**CONCEPT EVALUATIONS
And
COMMENTS RECEIVED**

**LINWOOD/EASTERN AVENUE
INTERCHANGE FOCUS AREA**

Eastern Corridor Segments II and III

Grade Separated Interchange Connecting Wilmer, Wooster, and Eastern

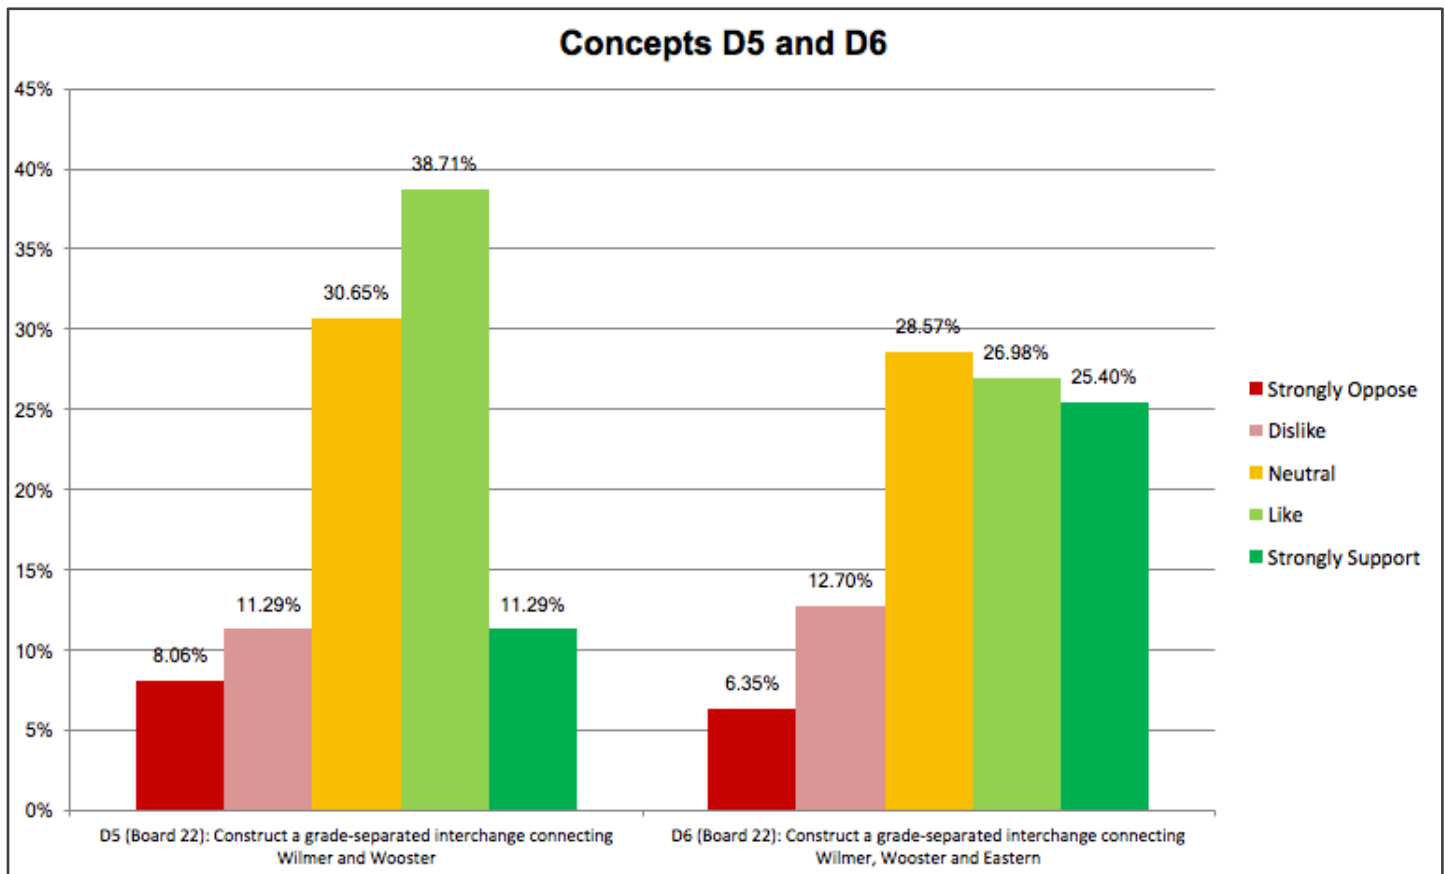
NO.	COMMENT	RESPONSE
1	D6 – I live here ask me why it would not be good. <i>[This respondent was strongly opposed to the concept.]</i>	Thank you for your comment. Your input is appreciated and will be taken into consideration as we evaluate the options and develop our recommendations.
2	Concept Number D6: I'm all in favor of improved pedestrian and bicycle access from Eastern Avenue to Armleder park!! However, I would like to see the connection between Wilmer/ Wooster and Eastern to be in a different location on Eastern. In this board #22 the plan is to go through my property's parking lot at 4785 Eastern Avenue; not only have I made a major financial investment in my property, 100 years old and has been in my family for that long. The building was the site of the Cincinnati Floor Company, a hardwood flooring business which built floors in national museums, businesses and residences. People still know the building as where that company operated. And many use it as a landmark. Parts of the building (the oldest parts) have been renovated using my own personal resources, keeping the historical nature of the building in mind, but repurposing its use-- currently it serves artists, musicians, a gallery and as a public or private event and performance space.	<p>Thank you for your comment. Your input is appreciated. Your comments and concerns will be taken into consideration as we evaluate the options and develop our recommendations.</p> <p>In response to the comments received and discussions of the Advisory Committee, a new alternative to bring a shared-use path across the SR 125 bridge over the railroad has been created. This would provide a path from Eastern Ave to Lunken Trail. If this connection across SR 125 proves to be viable, then it may be possible to eliminate the proposed connection on D6 from further consideration.</p>

3	D6 - Direct access to Eastern then Columbia Pkwy is nice	Thank you for your comment. Your input is appreciated and will be taken into consideration as we evaluate the options and develop our recommendations.
4	Option D6 - Connecting Wilmer with Wooster and Eastern is long overdue.	Thank you for your comment. Your input is appreciated and will be taken into consideration as we evaluate the options and develop our recommendations.

Red Bank and Colbank Intersection Improvements

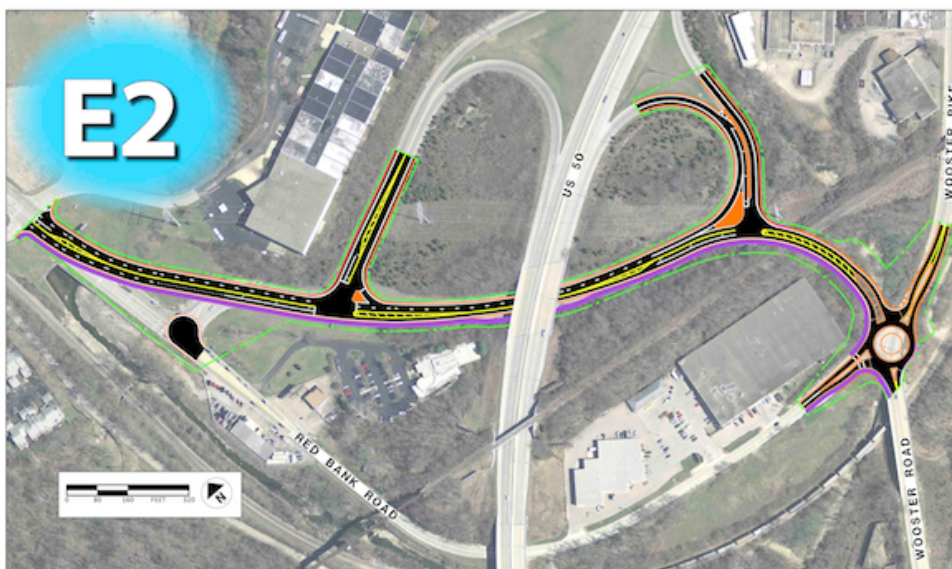
NO.	COMMENT	RESPONSE
1	The E2 option seems like a lot of trouble to accomplish the same as E1 for a lot more money. E1 is the way to go.	Thank you for your comment. Your input is appreciated and will be taken into consideration as we evaluate the options and develop our recommendations.

Extend Wooster to Tie Into Red Bank

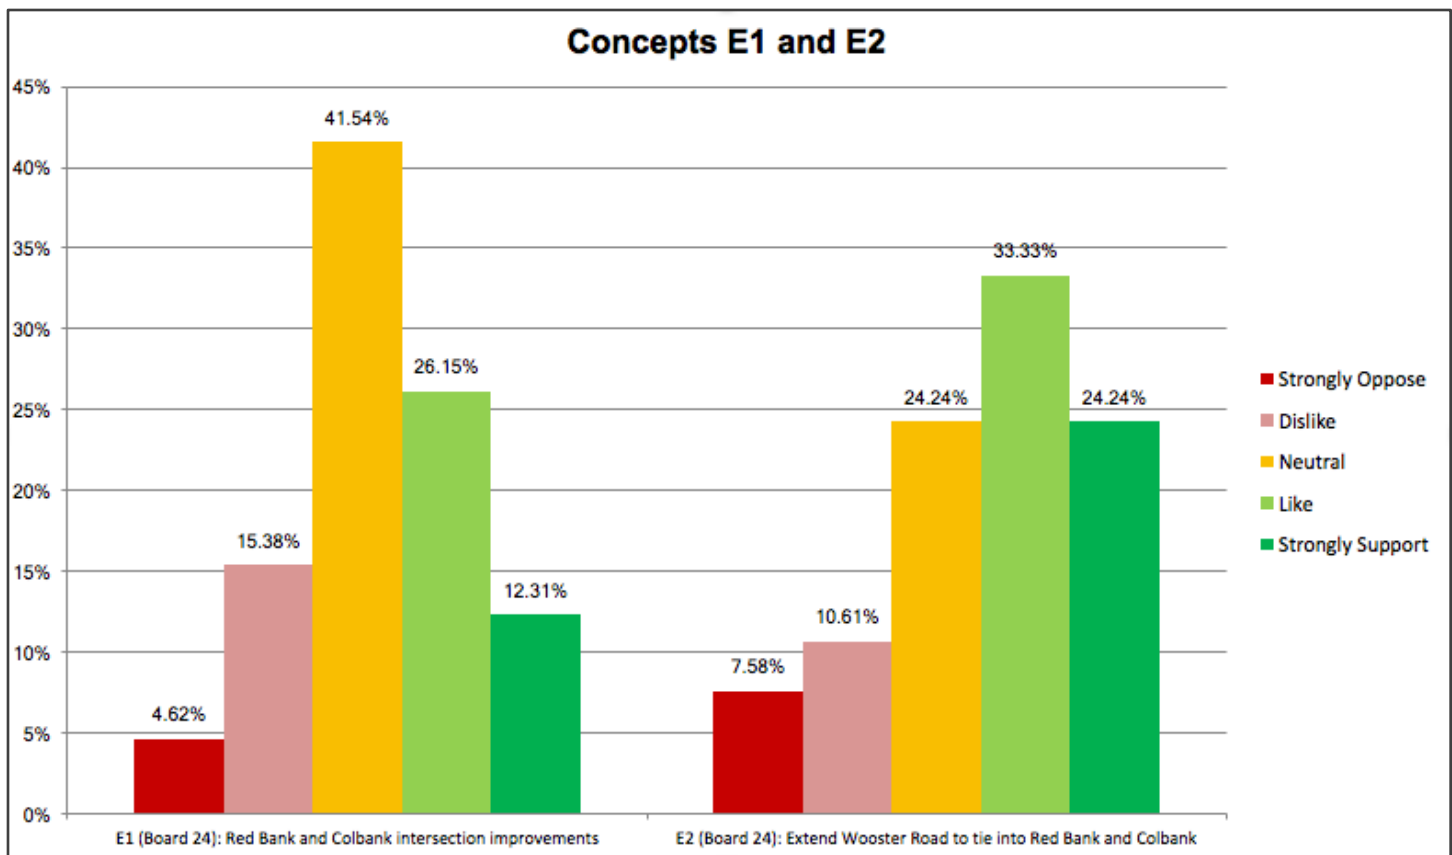
NO.	COMMENT	RESPONSE
1	E2 - Cul-de-sac on Red Bank Road?	Thank you for your comment. In this concept Wooster Road would extend directly to Red Bank at Woodland Road for all through-traffic. Businesses on existing Red

5	The E2 option seems like a lot of trouble to accomplish the same as E1 for a lot more money. E1 is the way to go.	Thank you for your comment. Your input is appreciated and will be taken into consideration as we evaluate the options and develop our recommendations.

NO.	COMMENT	RESPONSE
		<p>Bank would access at the roundabout intersection near Hyde Park Lumber. Further development on this alternative would include discussions with impacted property owners to determine access concerns.</p> <p>Your input is appreciated and will be taken into consideration as we evaluate the options and develop our recommendations.</p>
2	E2 - Would love to see the roundabout at Wooster Rd. & Wooster Pike have bike trail extended up Wooster Pike to connect US 50. I am building a restaurant, brewery & distillery at 3717 Jonlen Drive and would love to have people bike to our location	Thank you for your comment.
3	E2 - Traveling north on Red Bank -remove cul-de-sac. Allow access to businesses.	Thank you for your comment. Your input is appreciated and will be taken into consideration as we evaluate the options and develop our recommendations.
4	I'm concerned about bicycle safety in E2. Redirecting the exit ramp down to Wooster Road would redirect more traffic and traffic moving at a higher speed down onto the road that is the main connector to the Ohio-to-Erie Trail and is safest way to get to the Ohio River Trail from this part of town. It would introduce a lot of complexity unless protected bike lanes were added from Wooster Pike/Wooster Road down through to Armleder Park. This only works with E5 which I'm sure was pointed out in the face-to-face meetings that I could not attend :)	<p>Thank you for your comments. The shared-use path proposed in this concept is one piece of a larger bicycle/pedestrian connectivity plan shown in concepts E6 and E7.</p> <p>Your comments are appreciated and will be taken into consideration as we evaluate the options and develop our recommendations.</p>

Roundabout at Meadowlark and US 50

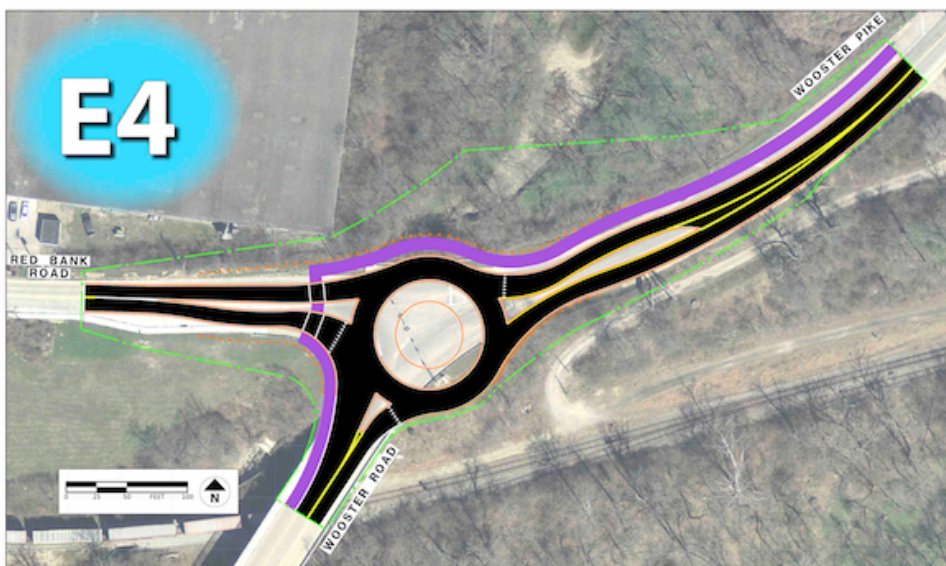
NO.	COMMENT	RESPONSE
1	E3 - potential for roundabout to 'lock up' if cars stack at light at Watterson. Also this involves widening part of Wooster to 2 lanes where it was just reduced to one a few years ago. Concerned about pedestrians crossing Wooster at the roundabout, especially bus commuters who use the adjacent parking lots.	<p>Thank you for your comment. Your input is appreciated and will be taken into consideration as we evaluate the options and develop our recommendations.</p> <p>When analyzing the roundabout, we evaluated the interaction with the Watterson intersection due to its proximity. The analysis indicates that eastbound queues from Watterson will not back up into the roundabout.</p>
2	E3 - if it really reduces delays	Thank you for your comment. Your input is appreciated and will be taken into consideration as we evaluate the options and develop our recommendations.

NO.	COMMENT	RESPONSE
3	E3 - this would be so much better!	Thank you for your comment. Your input is appreciated and will be taken into consideration as we evaluate the options and develop our recommendations.
4	I live in Fairfax behind the Frisch's and E3 seems to be the most cost-effective way to deal with a major traffic bottleneck at this time. If there isn't a plan to bypass Mariemont completely, this would at least ease some of the traffic as well as force people to slow down coming into the business district.	Thank you for your comment. Your input is appreciated and will be taken into consideration as we evaluate the options and develop our recommendations.
5	E3 - for continuous traffic some sound dampening such as walls or trees would be wonderful for residents of Nightingale and Chickadee.	Thank you for your comment. Your suggestions are appreciated and we will share them with the Village of Fairfax for their future planning.

Roundabout at Wooster and Red Bank

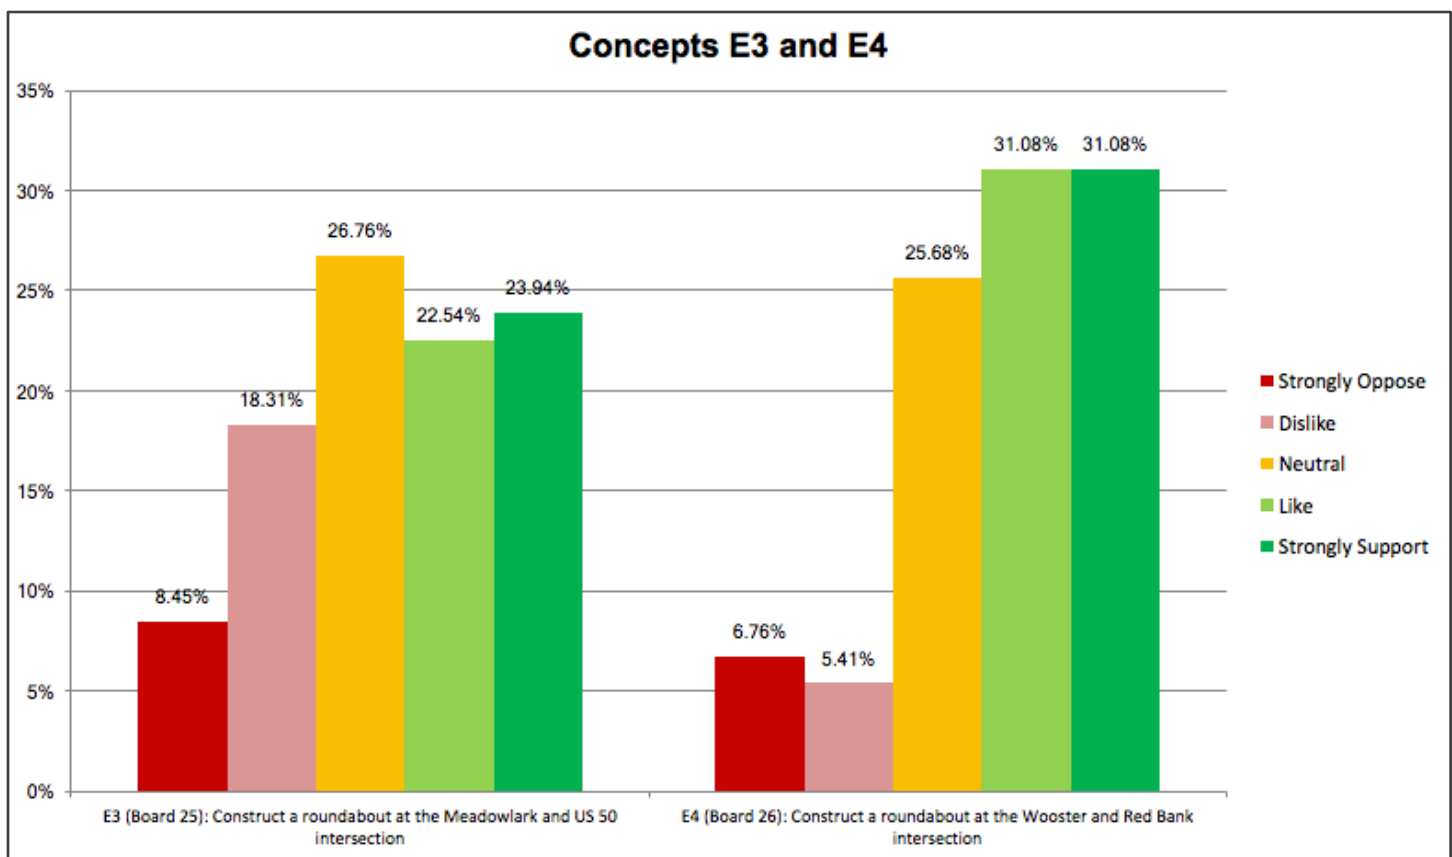
NO.	COMMENT	RESPONSE
1	E4 - if it improves visibility coming from Red Bank	Thank you for your comment. Your input is appreciated and will be taken into consideration as we evaluate the options and develop our recommendations.
2	E4 doesn't seem to accomplish anything despite costing time/money to construct.	Thank you for your comment. Your input is appreciated and will be taken into consideration as we evaluate the options and develop our recommendations.

E5: Shared-Use Path Along US 50

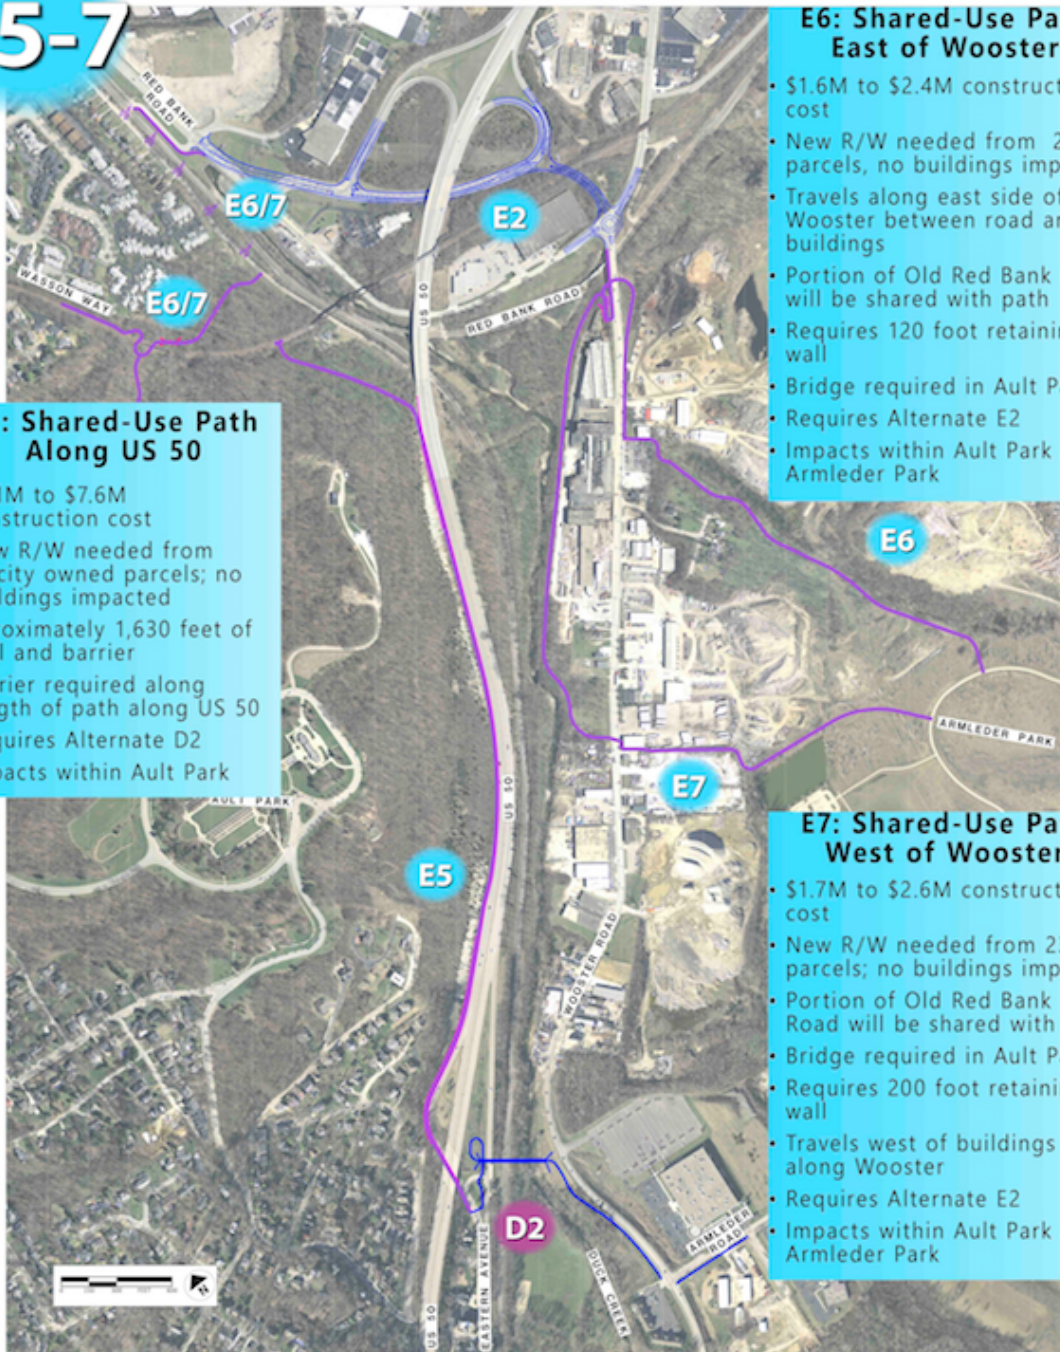
NO.	COMMENT	RESPONSE
1	E5 - Like keeping shared-use path near/ in Ault Park- safer, healthier and more scenic. Would be great to incorporate with ped. RR former trestle.	Thank you for your comment. Your input is appreciated and will be taken into consideration as we evaluate the options and develop our recommendations.
2	E5 seems like a disaster as far as costs are concerned. As difficult as it is to get any funding for bicycle-dedicated work in this city, I just cannot imagine it would get done if it was selected.	Thank you for your comment; your input is appreciated.

| 2 | On E5 (Board 26), I don't want to be biking next to cars and inhaling smog, would MUCH prefer E6 where you are riding along trees and away from cars | Thank you for your comment. Your input is appreciated and will be taken into consideration as we evaluate the options and develop our recommendations. |
| 4 | Other route options (E6, E7) put pedestrian/ bicyclist right next to industrial sites with heavy air contaminants and truck traffic. | Thank you for your comment. Your input is appreciated and will be taken into consideration as we evaluate the options and develop our recommendations. |

E6: Shared-Use Path East of Wooster

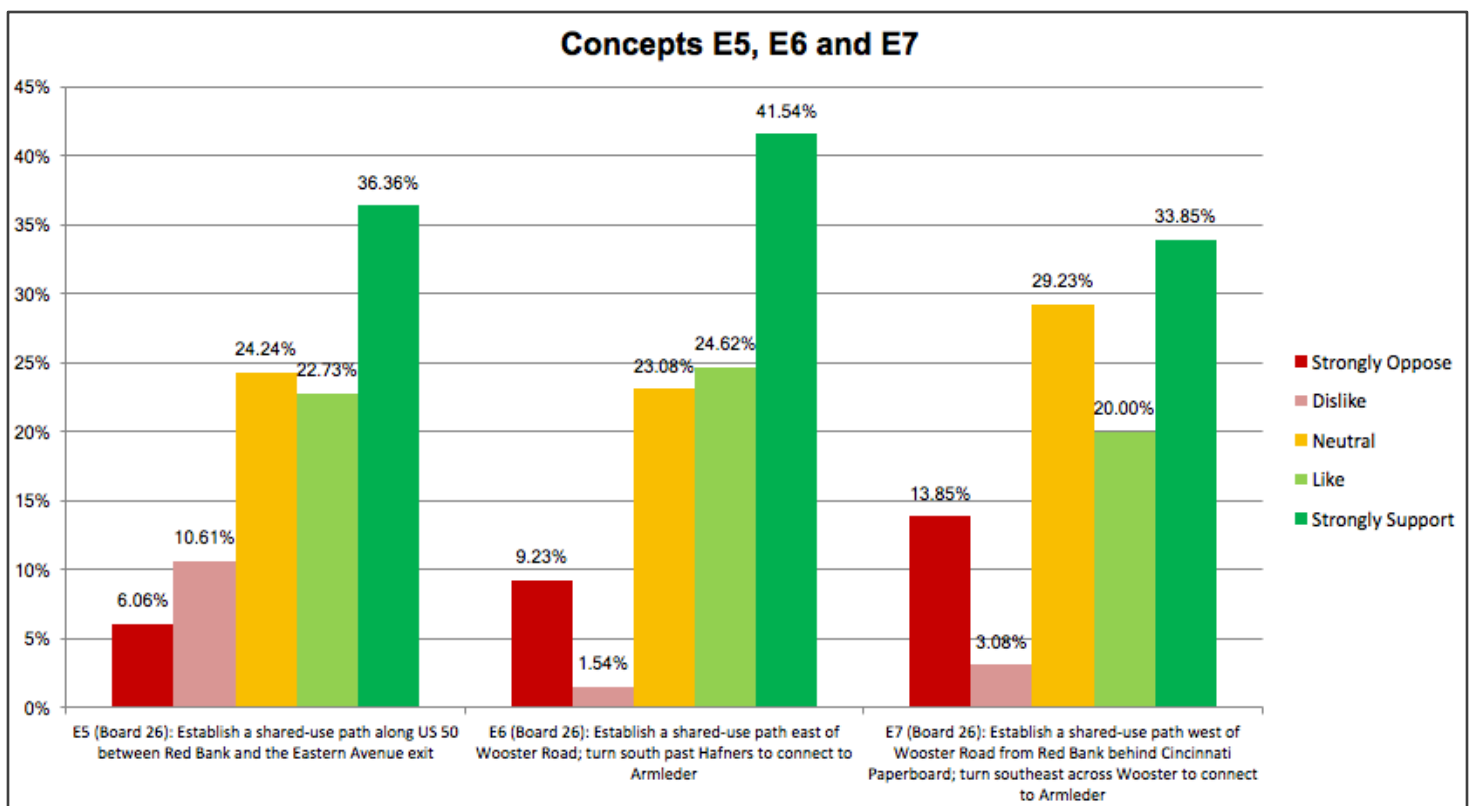
| 1 | The E7 trail would be along the pond at Armleder and increased traffic there would disturb wildlife and birds that nest there/use the pond | Thank you for your comment. Your input is appreciated and will be taken into consideration as we evaluate the options and develop our recommendations. |

| 1 | E5-E6-E7 - See comments about shared-use paths on page 3 [<i>Respondent shared a general comment about all of the shared-use path options: while I am not opposed to adding these at some point, there is a much greater need to alleviate the vehicle traffic and those issues need to be addressed first</i>]. | Thank you for your comments. Your input is appreciated and will be taken into consideration as we evaluate the options and develop our recommendations. |
| 3 | Prefer E6 or E7 over E5 – cheaper. | Thank you for your comment. Your input is appreciated and will be taken into consideration as we evaluate the options and develop our recommendations. |

NO.	COMMENT	RESPONSE
5	E6 and E7 make the most sense to me and hopefully E2 isn't selected which would ruin those as options. E6 and E7 provide the best connections to the other trails like Wasson Way and the Ohio River Trail and would be the most cost-effective ways of making those connections. I'd knock on doors to convince people to get E6 or E7 done as that stretch of Wooster Road is the most dangerous stretch for me until I've almost arrived at my work on Glenway Ave.	Thank you for your comment. Your input is appreciated and will be taken into consideration as we evaluate the options and develop our recommendations.
